Deadline 8 submission

This submission sums up issues where we remain in disagreement with the Applicant.

EA3 HVDC Cable Trench

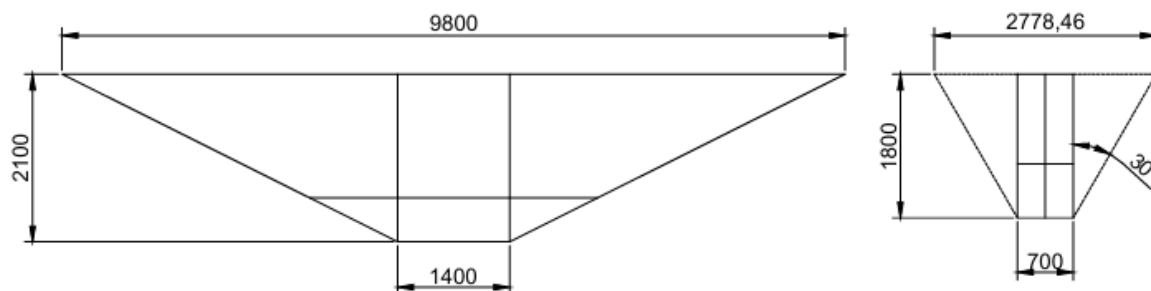
83. The drawings for the EA3 HVDC underground trenches show parallel sides with a width of 0.7m and a total depth of 1.8m. The dimensioning of the associated layout drawing appears to allow for a trench width of 1m. One of the sectional drawings also shows dashed lines at 30° to the trench sides. Assuming that this is to allow for trenches with splayed sides to be used in some circumstances, the resulting trench width at the surface has been calculated at 2.778m. As established in [REP7-568] this compares with a typical width of 2m for both the Tarchon Interconnector HVDC cable trench and the Hornsea 3 HVDC trenches (both with splayed sides).

are slightly narrower at 560mm, but the 280mm (140mm x 2) total difference over two trenches is not significant relative to the scale of the resulting cable swathes.

The Applicant’s proposed mitigation hierarchy

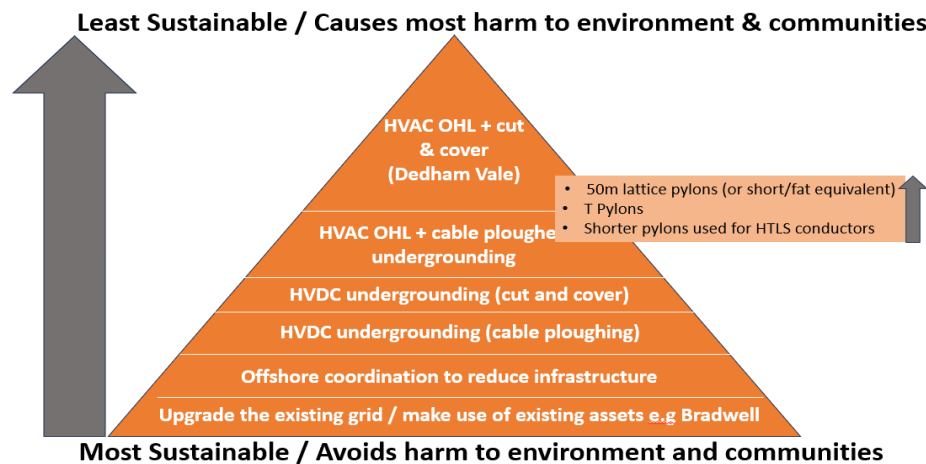
119. We have serious concerns about the *mitigation* hierarchy proposed by the Applicant in 8.4.15:

120. This cannot be accepted at face *value* – it needs to be evidenced, and supported by analysis such as Treasury Green Book analysis and environmental comparisons. **It is unjustified, inaccurate, has no foundation in policy or legislation, and cannot be relied on.** In fact, contradicts many of the NPS policies. Our own hierarchy is based on evidence submitted during four years of consultations and six months’ of Examination:
